# Access Compliance Report

Intersection ID: N/A	Main Street: MACDARA_GLENN_CT	Cross Street: FIVE_KNOLLS_DR	Location: NE
ADA ID: 101A329D06A6	Ramp Type: PerpDiag	Initial Pass/Fail: Fail	Overall Compliance: No
		Severity Score: 8.75

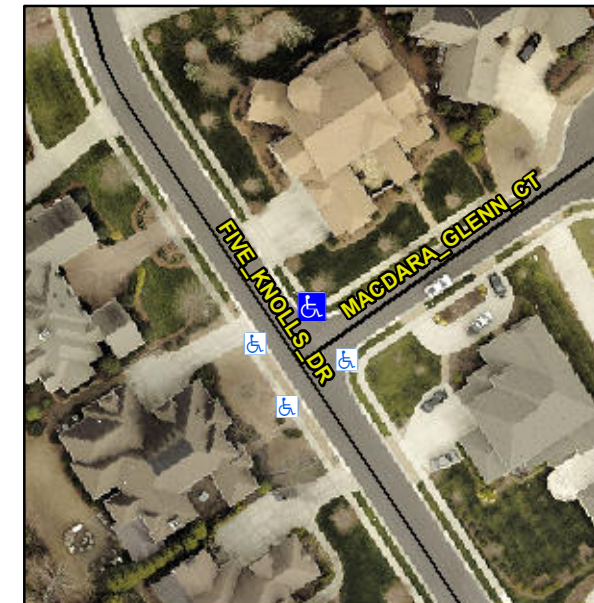
**Not Found, R304.5.1**

Compliance	Description	Data	Compliance	Description	Data
N/A	Ramp Length (in)	50.0	Yes	Ramp Slope (%)	5.2
No	Ramp Width (in)	46.0	Yes	Ramp XSlope (%)	1.4
N/A	Flare Type LT	N/A	N/A	Flare Type RT	N/A
N/A	Flare Slope LT (%)	N/A	N/A	Flare Slope RT (%)	N/A
N/A	Flare Traversable LT?	N/A	N/A	Flare Traversable RT?	N/A
N/A	Landing Length (in)	N/A	N/A	DWS Provided?	N/A
N/A	Landing Width (in)	N/A	N/A	DWS Contrast?	N/A
N/A	Landing Slope (%)	N/A	N/A	DWS Length (in)	N/A
N/A	Landing X Slope (%)	N/A	N/A	DWS Full Width?	N/A
N/A	Landing Curb? (Y/N)	N/A	N/A	DWS Offset (in)	N/A
N/A	Shared Landing?	N/A			
N/A	Gutter Ponding?	N/A	N/A	Gutter Slope (%)	N/A
N/A	Gutter Lip Ht (in)	N/A	N/A	Gutter X Slope (%)	N/A
N/A	Painted X Walk1?	No	N/A	Painted X Walk2?	No
	X Walk 1 Direction	To W		X Walk 2 Direction	To S
N/A	X Walk 1 Width (in)	N/A	N/A	X Walk 2 Width (in)	N/A
	X Walk 1 Slope (%)	3.2		X Walk 2 Slope (%)	3.0
	X Walk 1 X Slope (%)	3.1		X Walk 2 X Slope (%)	1.7

**Remove & Replace Curb Ramp With Two New Directional Ramps or Equivalent.**
